CITY OF SUNNYVALE REPORT
ZONING ADMINISTRATOR HEARING

File Number: 2013-7013 **Permit Type:** Use Permit

Location: 150 Lawrence Station Rd. (near Kifer Rd.) (APN: 216-27-052)

Project Description: To allow the expansion of an existing fuel facility at Costco.

FIGURE **2**

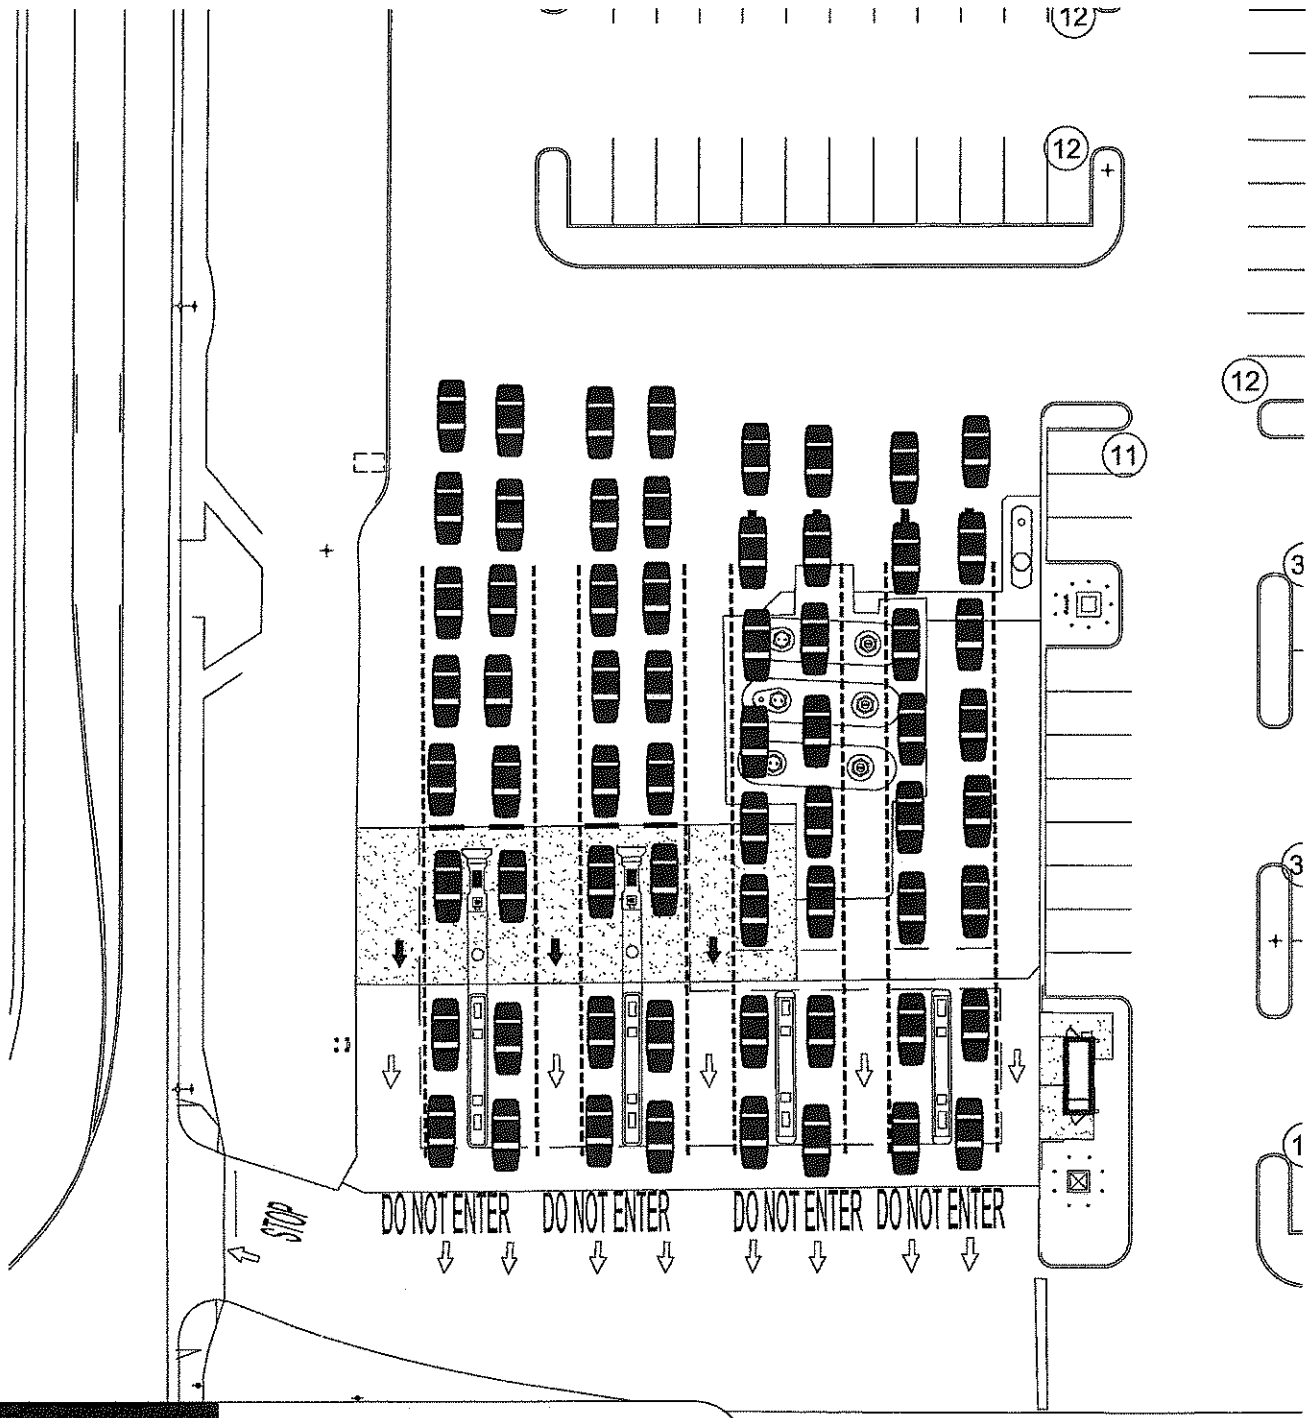
As requested by the City of Sunnyvale, Figure 2 illustrates the fuel station area vehicle queuing capacity or how many vehicles can be accommodated in the queuing lanes. As seen in Figure 2, the proposed expansion site plan has the capacity to accommodate a total of up to 62 vehicles in the fuel station area including those at the pumps or 42 vehicles waiting behind the pumps. It is important to note that this is not the expected queue for the fuel station but represents the queue capacity of the fuel station area for storage. A queue study was completed at the existing Sunnyvale Costco Gasoline facility in September 2012 to document the existing peak period queues. At that time, the peak periods exhibited queuing characteristics summarized in Table 1.

As can be seen from Table 1, the current peak period maximum queue observed on site was a total of 43 vehicles. This is significantly less than what could be accommodated by the proposed site plan (which is 62 vehicles) even without considering the reduction in queuing expected once more pumps are provided to process the peak period demands.
